**TECHNISCHE INFORMATION NR.
SI20-020****SERVICE INFORMATION NO.
SI20-020****I. TECHNISCHE ANGABEN****1.1 Betroffene Flugzeuge**

Service Bulletin SB-912-037 / SB-914-023 der Firma Rotax betreffend möglichen Einbau eines stärkeren Starters bei Rotax Motoren Type 912 und 914.

INSTALLATION OF AN ELECTRIC STARTER WITH ENHANCED POWER FOR ROTAX® ENGINE TYPE 912 AND 914 (SERIES) SB-912-037 R1 SB-914-023 R1

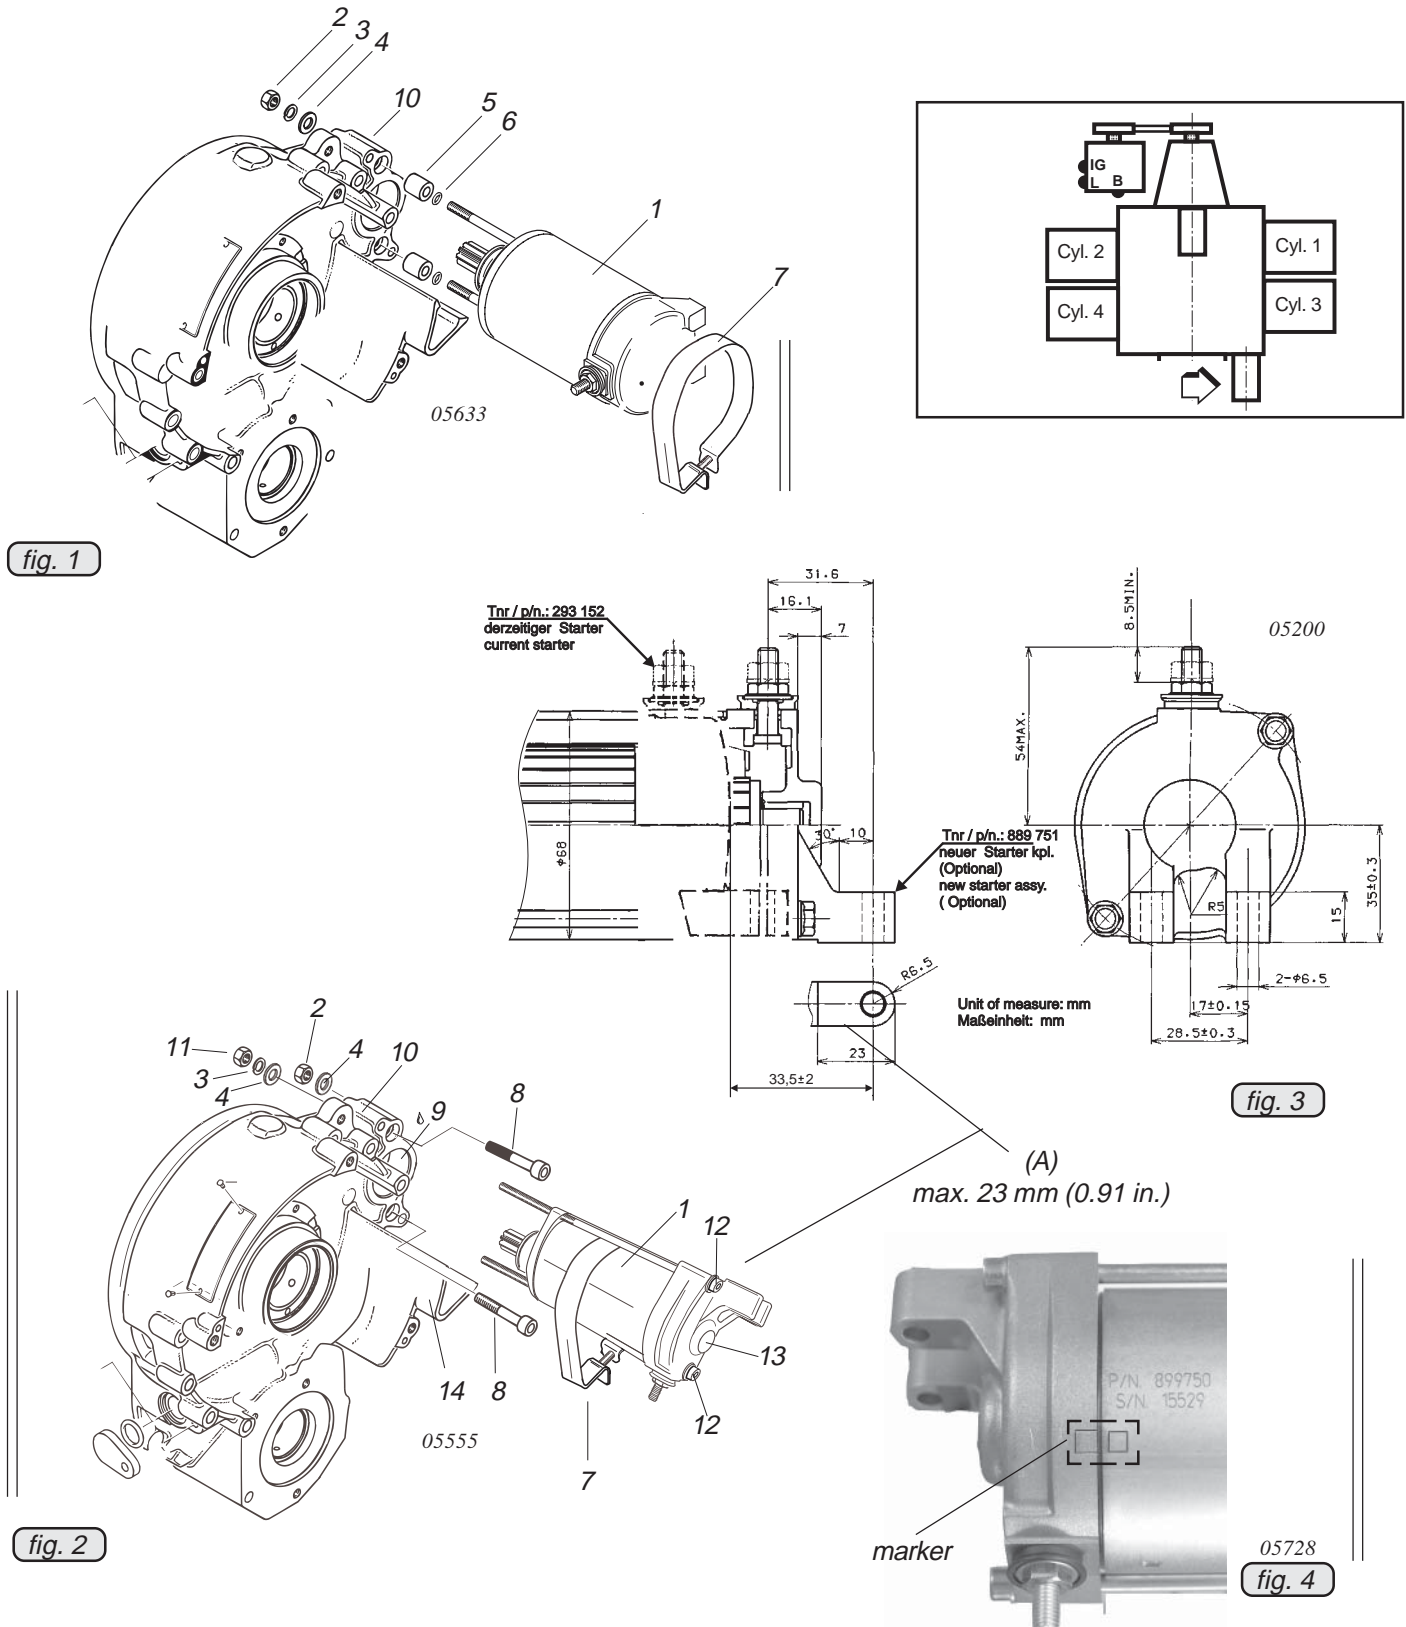
Depending on aircraft installation, lugs (A) on the electric starter may be shortened by up to 23 mm (0.91 in) as shown in figure 3.

Disconnect positive terminal from starter. Remove 2 hex. nuts M5 (2) with lock washers (3) and washers (4) at rear of ignition housing (10). Remove electric starter (1) by loosening securing clamp 76 (7). The electric starter is axially kept in position by 2 spacers (5) and O-rings (6).

Mounting holes for old starter are to be plugged off with 2 Allen screws M5x45 (8), washer (4) and lock nut M5 (2) with 6 Nm (4 in.lb). Clean electric starter mounting surface (9) inside the ignition housing. Slightly lubricate mounting surface (9) with multipurpose grease or engine oil. Slide new electric starter set (1) into ignition housing (10). Tighten electric starter with washer (4), lock washer (3), and hex. nut M5 (11) evenly with 6 Nm (4 in.lb).

■ **CAUTION:** Cyl. screws M5x180 (12) are used for the internal attachment of the starter components. In the course of the mounting of the starter the cyl. screws M5x180 (12) may not be rotated, since it could shift the position of the bearing plate (13) and possibly cause a malfunction of the starter. The markings on the rotor bearing and starter housing must be aligned. (see fig. 4)

Bild 1

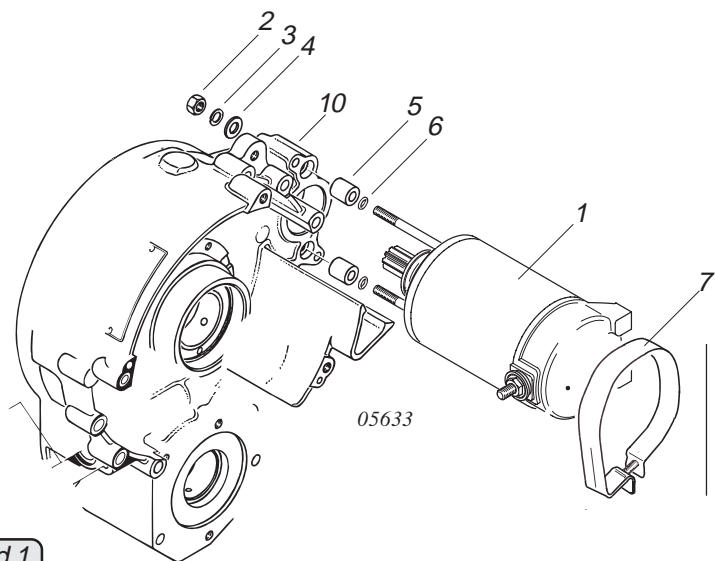
Pluspol am Starter abklemmen. 2 Sk-Muttern M5 (2) mit Federringen (3) und Scheiben (4) an der Hinterseite des Zündergehäuses (10) entfernen. Durch Lösen der Spannschelle 76 (7) kann der Elektrostarter (1) abgenommen werden. Der Elektrostarter wird durch 2 Distanzhülsen (5) und O-Ringe (6) axial in Position gehalten.

Bild 3

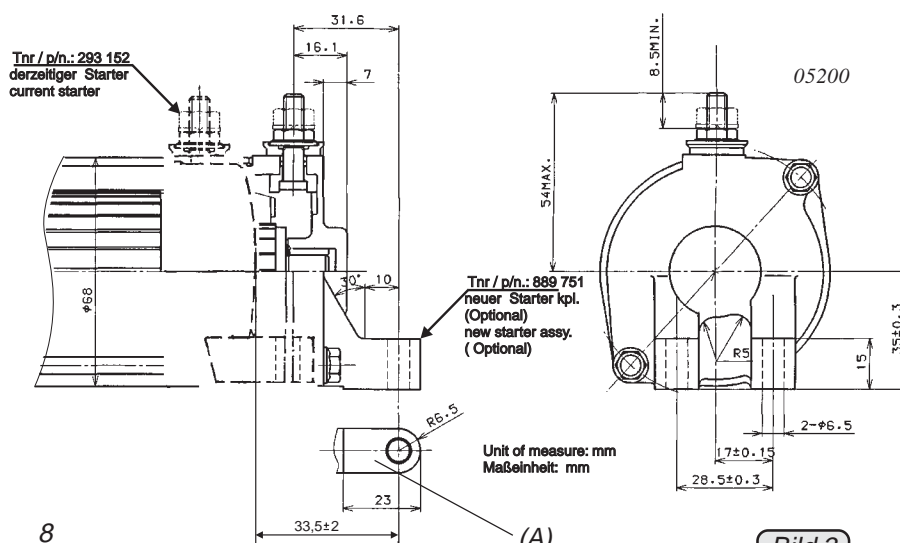
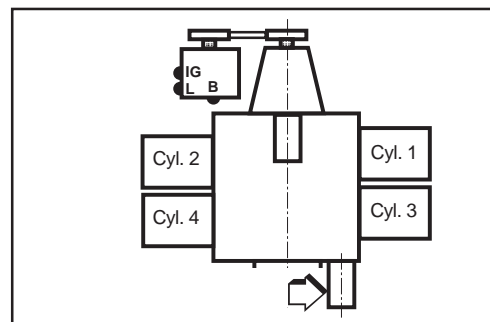
Je nach Abhängigkeit der LFZ-Installation können die Befestigungslaschen (A) am E-Starter um den in Bild 3 beschriebenen Wert gekürzt werden.

Bild 2

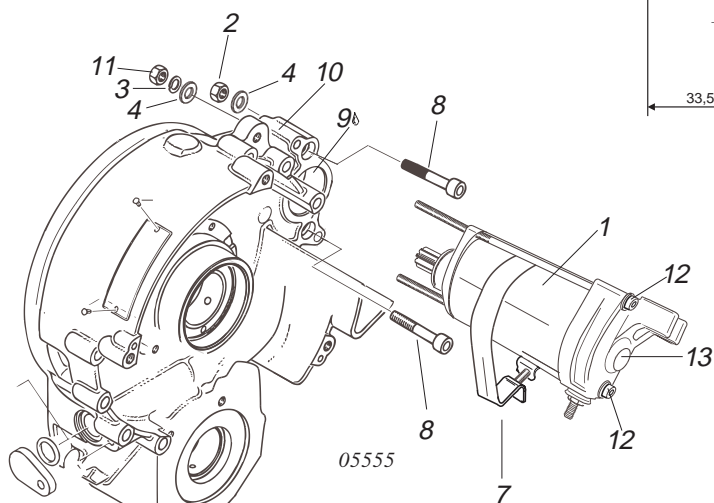
Bisher verwendete E-Starterbefestigung am Kurbelgehäuse mit 2 Stk-Innensechskantschrauben M5 x45 (8), Scheibe (4) und Sicherungsmutter M5(2) mit 6 Nm festziehen. Auflagefläche für E-Starter im Zündergehäuse reinigen. Lagerung (9) leicht mit Mehrzweckfett LZ einfetten. Neuen Elektrostarter kpl. (1) in das Zündergehäuse (10) schieben. Elektrostarter mit Scheibe (4) Federing (3) und SK-Mutter M5 (11) gleichmäßig mit 6 Nm festziehen.

◆ **HINWEIS:** Die Distanzhülsen (5) und O-Ringe (6) entfallen bei dieser Anwendung.

Bild 4

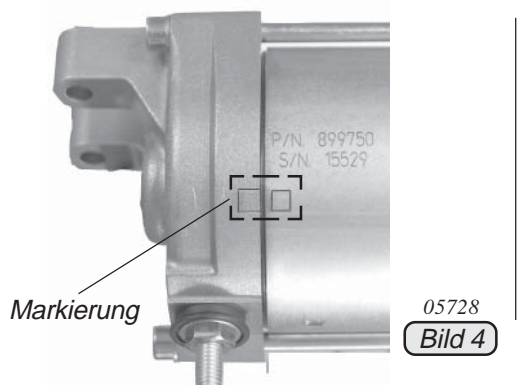
■ **ACHTUNG:** Zyl.Schraube M5x180 (12) dient zur „internen“ Befestigung der Starterkomponenten. Im Zuge des Anbaues des Starters darf die Zyl.Schraube M5x180 (12) nicht mehr verdreht werden, da es dadurch zu Positionsänderung des Lagerschildes (13) und in Folge zu einer Fehlfunktion kommen könnte.

Die Markierung am Kollektorlager und Startergehäuse müssen übereinstimmen.
